❖ ADDENDUM NO. 1 ❖

**◆
A NEW BUILDING**

SANDOVAL COUNTY RECREATION CENTER

Please note this Addendum forms a part of the Contract Documents and modifies them in the manner and extent set forth below. All other contents, terms, and conditions of the Documents remain unchanged.

A310

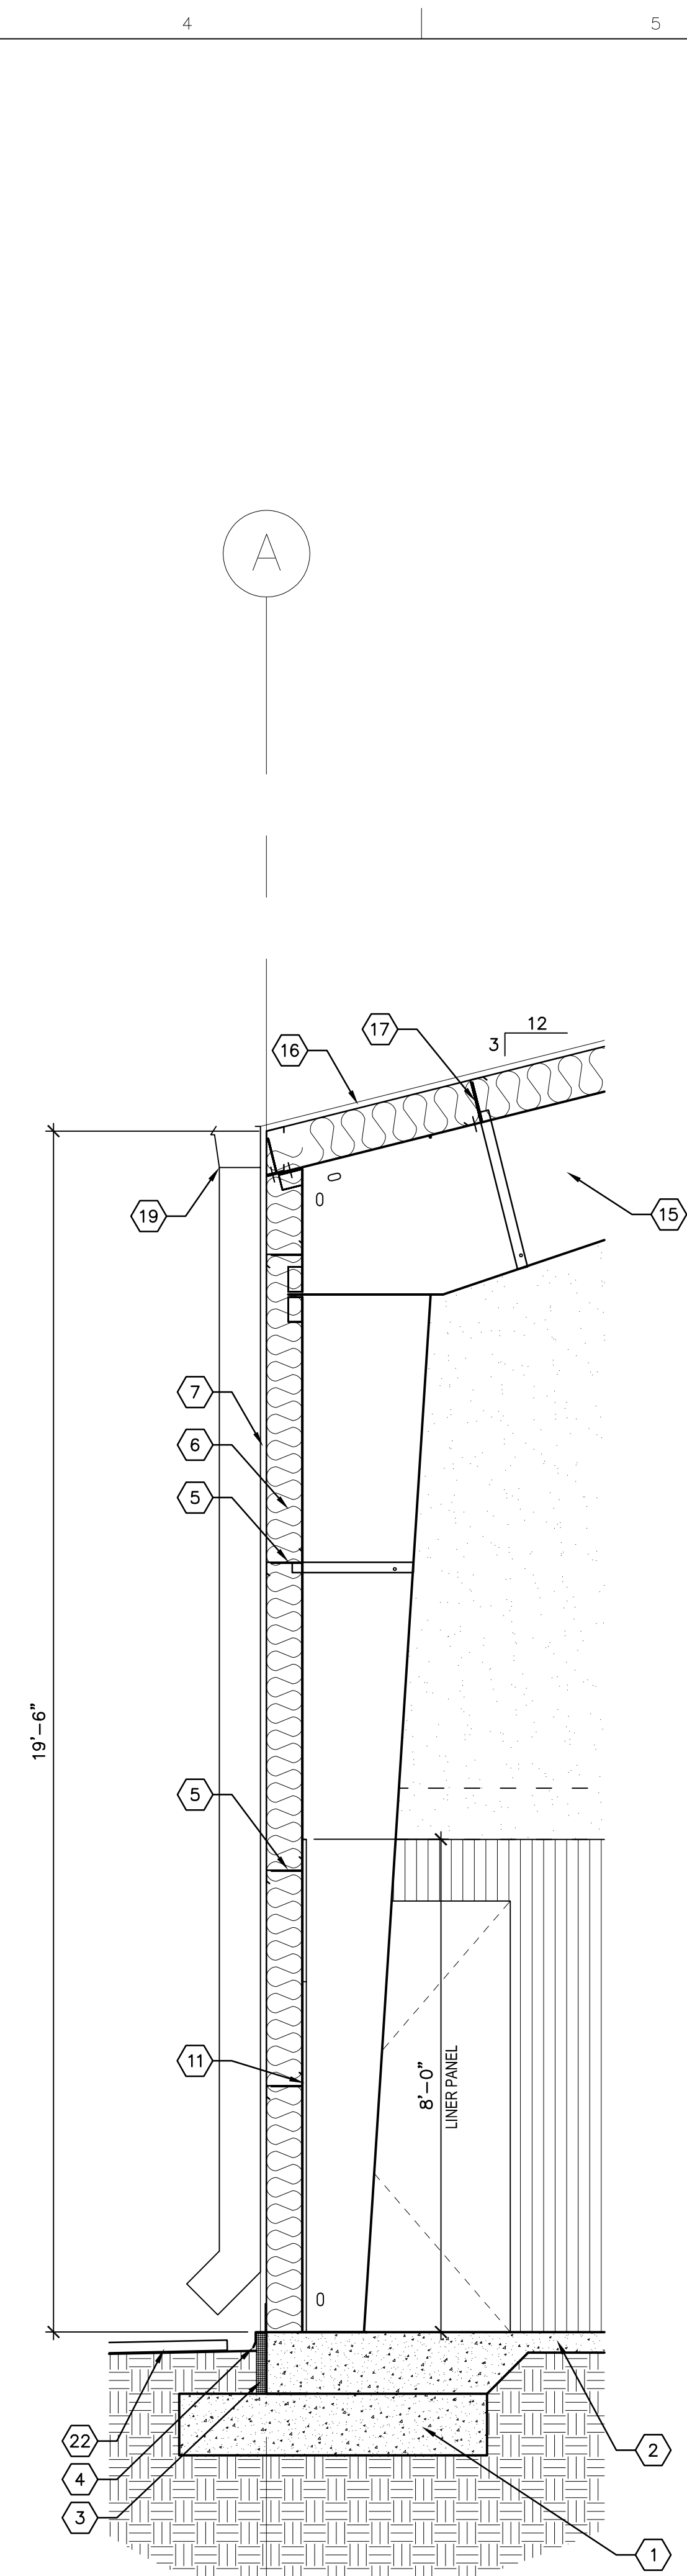
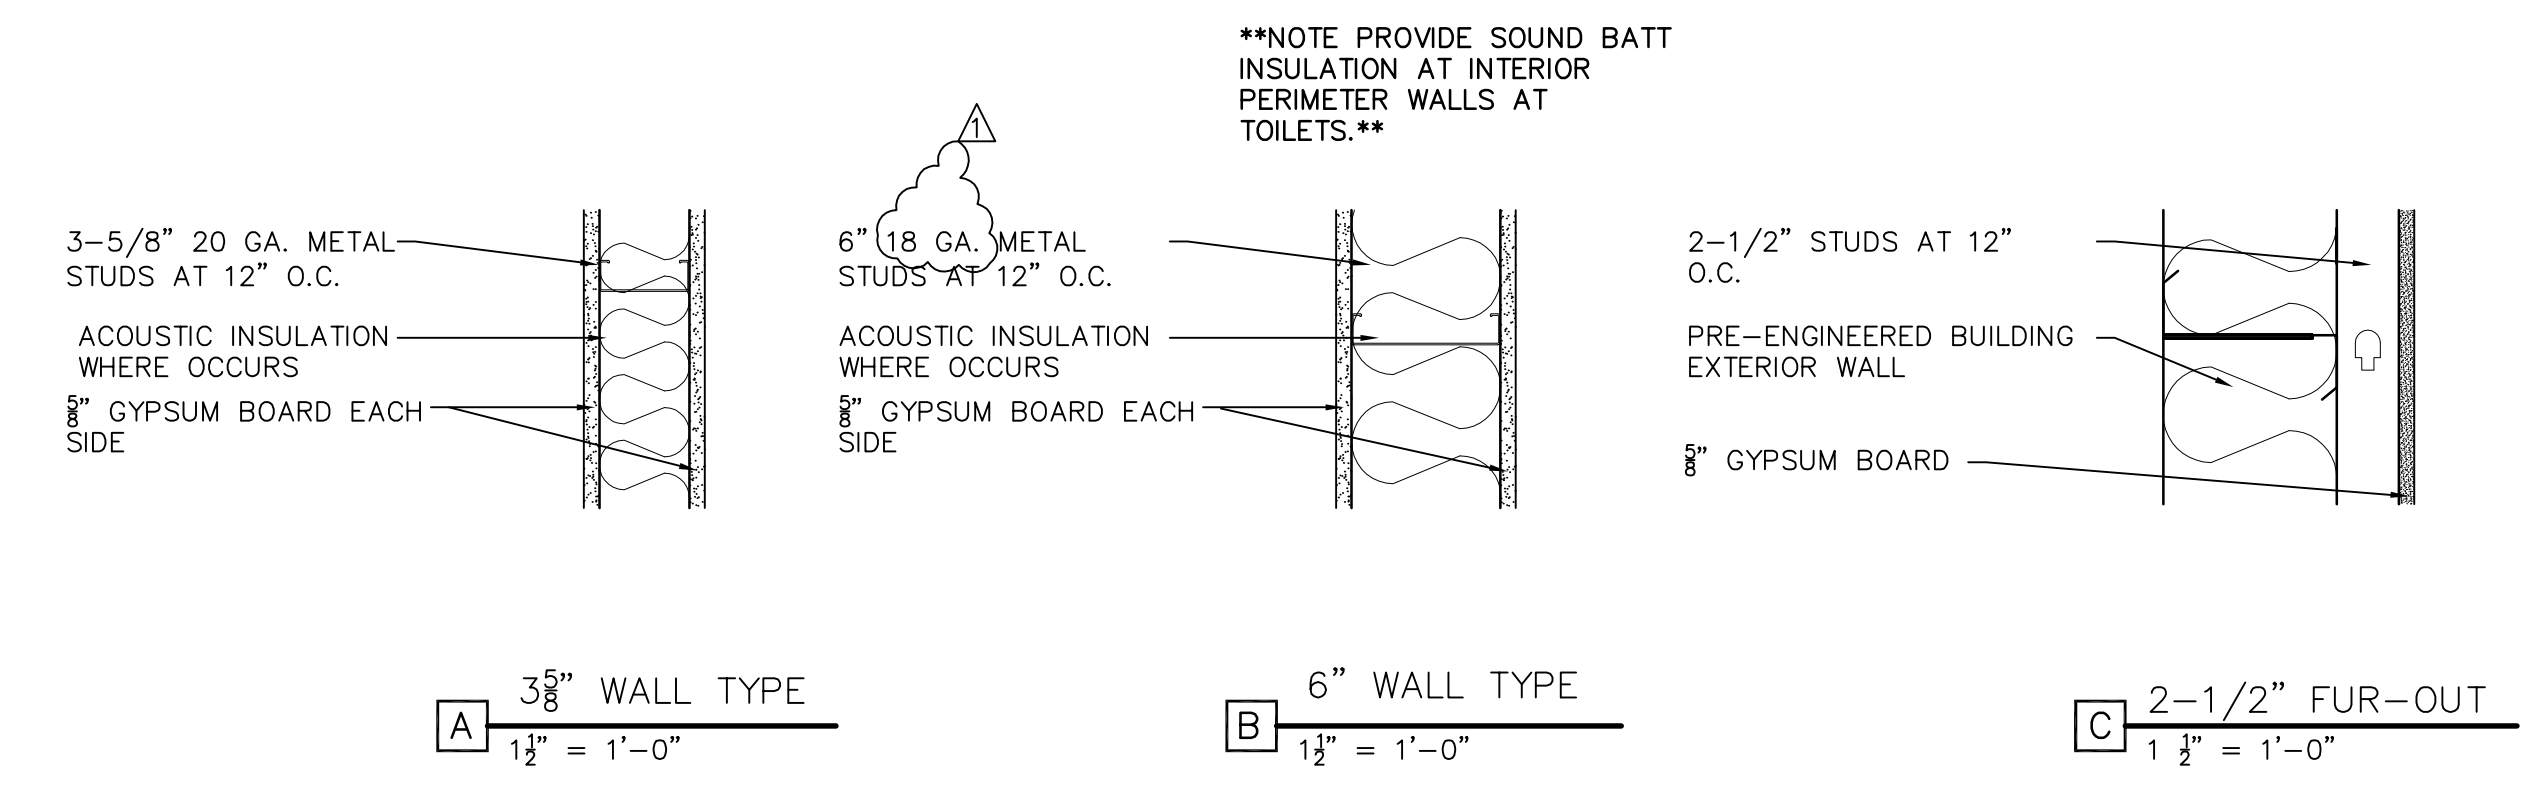
B. Sheet A310, Wall Sections

1. Change Wall Type 'B' to be 18 GA (Not 20GA).
